TECHNICAL SERVICE BULLETIN

Illuminated MIL With DTCs P0455, P0456, P0442 And/Or P04EE

25-2308

Ford
2022-2024 Maverick

Figure 1 - Location Of The Chafing/Rubbing Condition

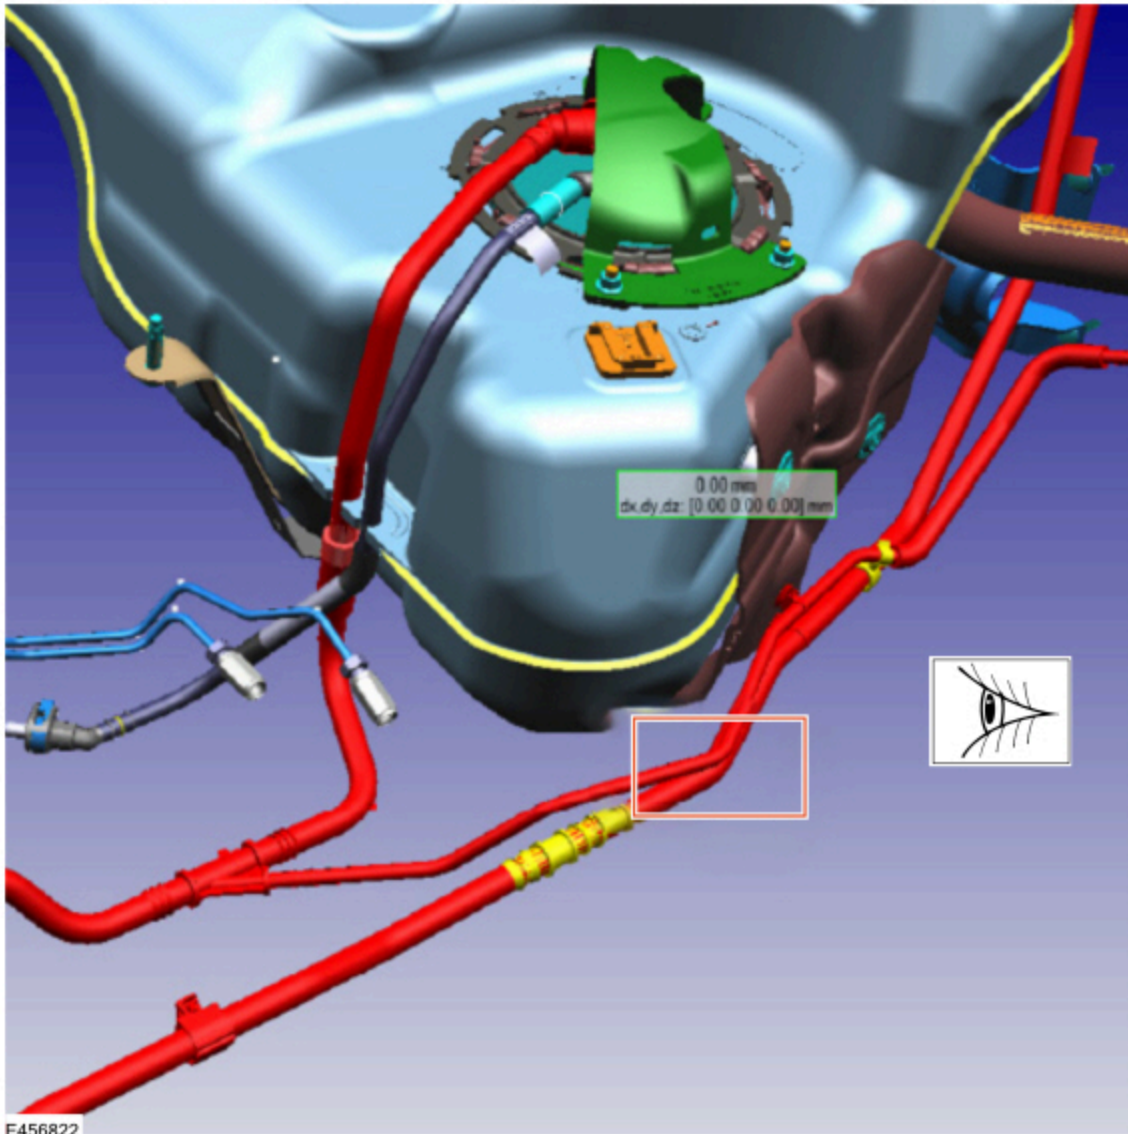
Issue: Some of the vehicles listed in the Model statement above may exhibit an illuminated MIL with DTCs P0455, P0456, P0442 and/or P04EE. This may be due to a chafing or rubbing condition between the fuel vapor canister line and the air vent hose.

1. Inspect the fuel vapor canister line for chafing or rubbing damage caused by contact against the air vent hose. Is the fuel vapor canister line damaged due to chafing or rubbing contact against the air vent hose? (Figure 1)

Action: For vehicles that meet all of the criteria in the Issue and Model statements, follow the Service Procedure to install a new fuel vapor canister line that includes a clip to maintain the gap with the air vent hose.

Figure 4

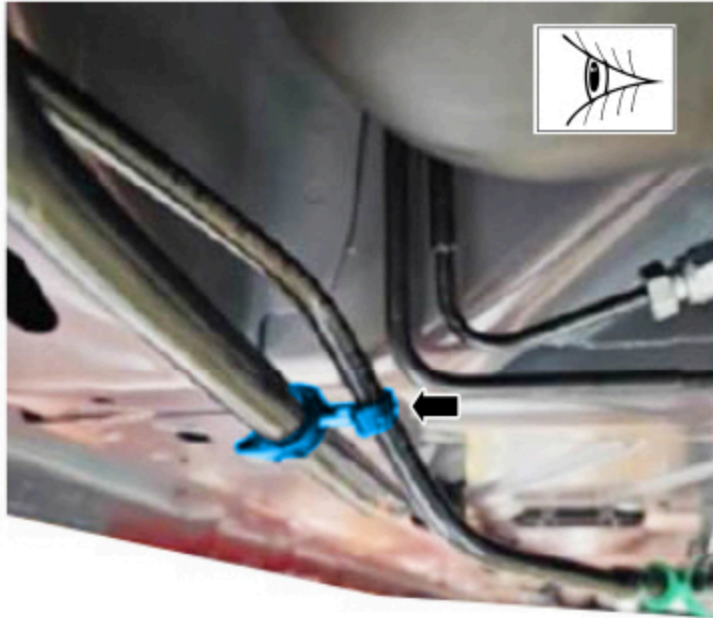
(1). Discard the fuel vapor canister line.
5. Install a new fuel vapor canister line.
NOTE: The new fuel vapor canister line includes a clip to maintain the gap against the air vent hose. (Figure 4)

- (1). Secure the new vapor canister line to the air vent hose using the new clip.
6. To assemble the vehicle, reverse the removal procedure.
7. Clear DTCs using FDRS.
